AGENDA
PLANNING COMMISSION
116 WEST NEEDLES
BIXBY, OKLAHOMA
May 18, 2015 6:00 PM

MINUTES
PLANNING COMMISSION
116 WEST NEEDLES
BIXBY, OKLAHOMA
April 20, 2015 **6:00 PM**

To: Bixby Planning Commission
From: Erik Enyart, AICP, City Planner
Date: Wednesday, April 08, 2015
RE: Report and Recommendations for:
BZ-379 – JR Donelson for Bill J. Ramsey Trust

AS101

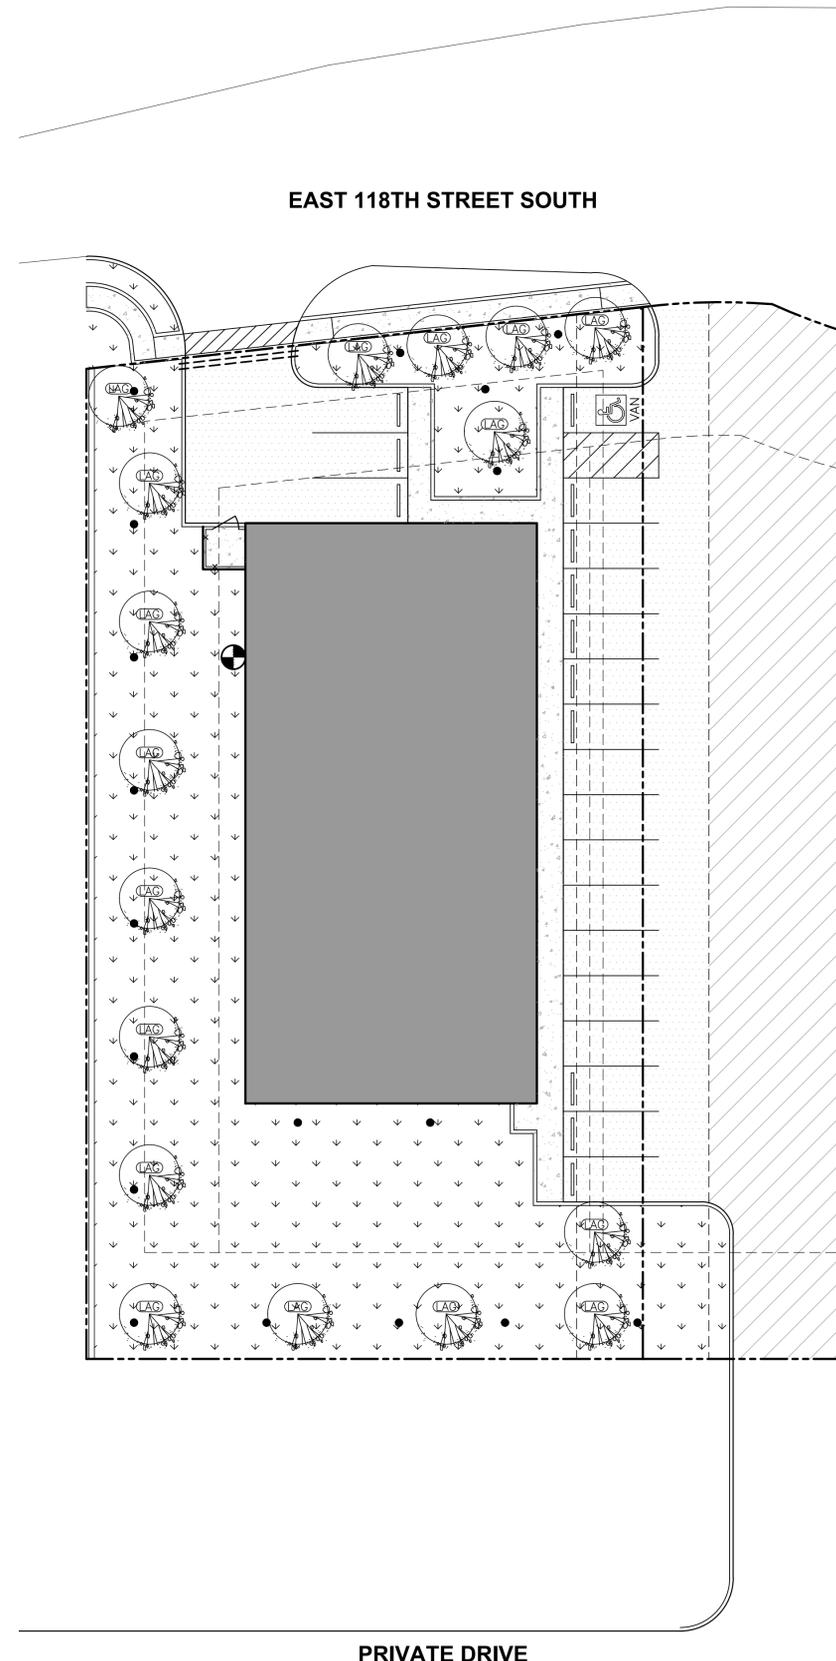
The Detailed Site Plan was prepared by W Design, LLC of Tulsa. The submitted plan-view Site Plan drawing consists of "Architectural Site Plan" drawing AS100 and "Floor Plan First Floor" drawing A201 (hereinafter, individually or together, sometimes "Site Plan" or "site plan"). The landscape plan consists of a "Landscape Plan" drawing AS101. Appearance and

A301

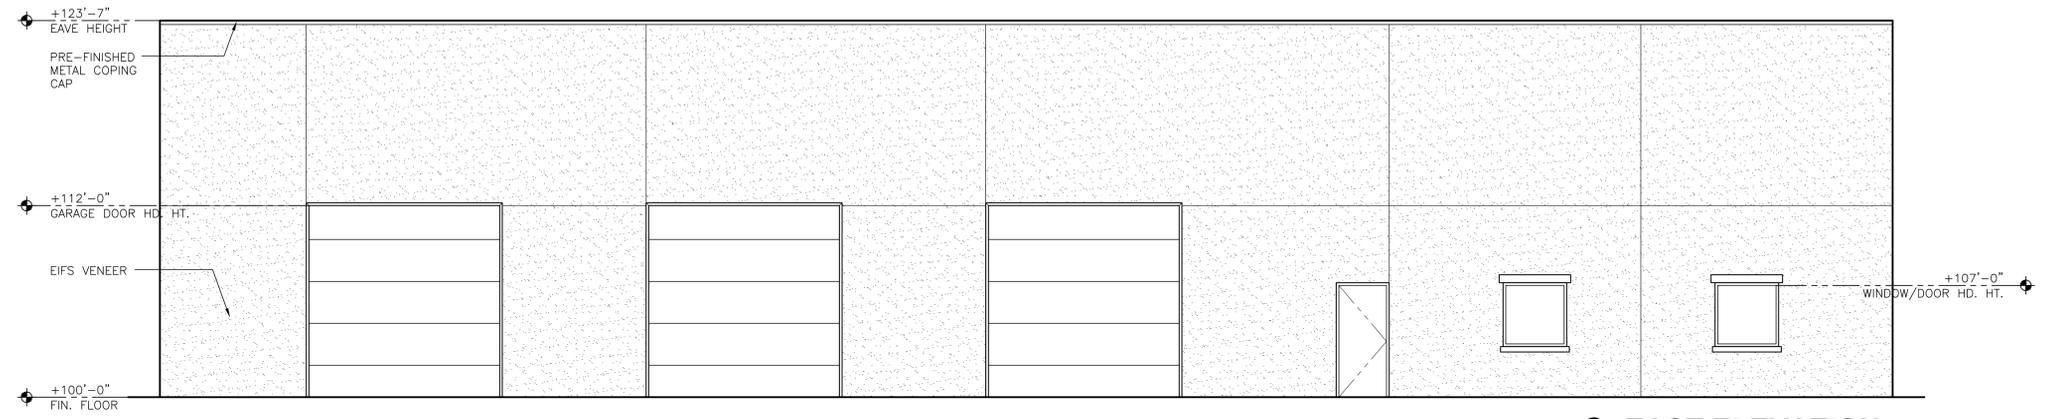
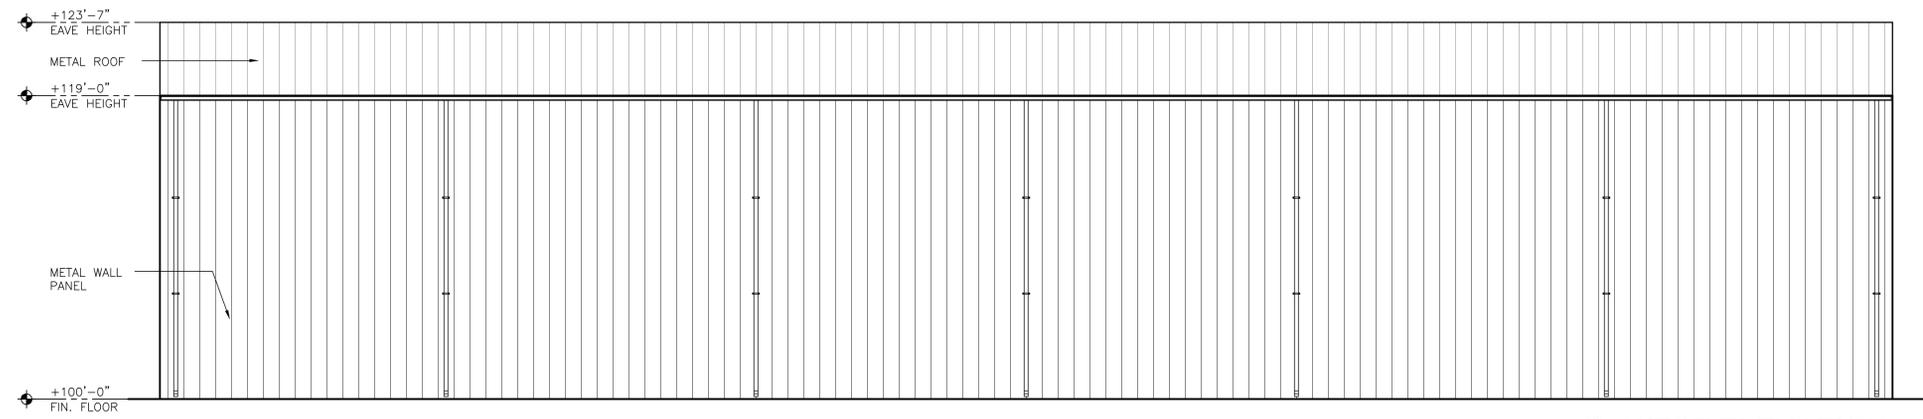
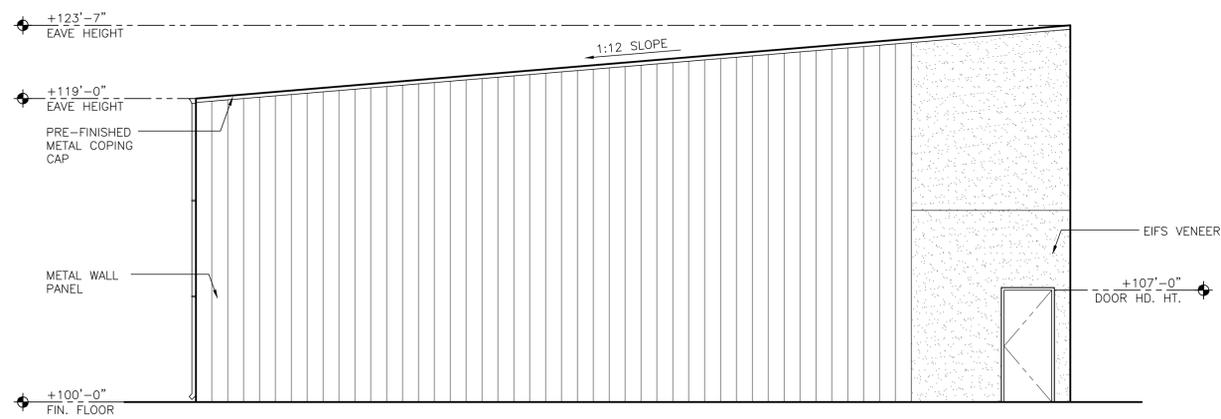
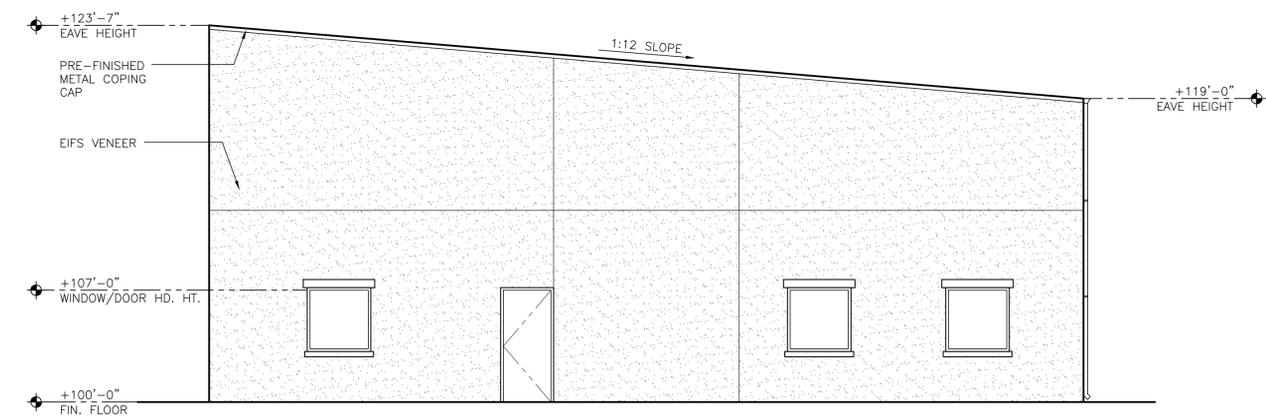
Exterior Materials and Colors. Appearance and height information is provided on the “Exterior Elevations” drawing A301. The PUD has a 35’ maximum building height in Development Area B / Lot 2, Block 1, *Bixby Jiffy Lube*, and the plans propose a shed-roof design with the highest elevation along the east-facing elevation at 23’ 7” and the lowest elevation along the west-facing elevation at 19’. The shed-roof is proposed to have a 1:12 pitch.
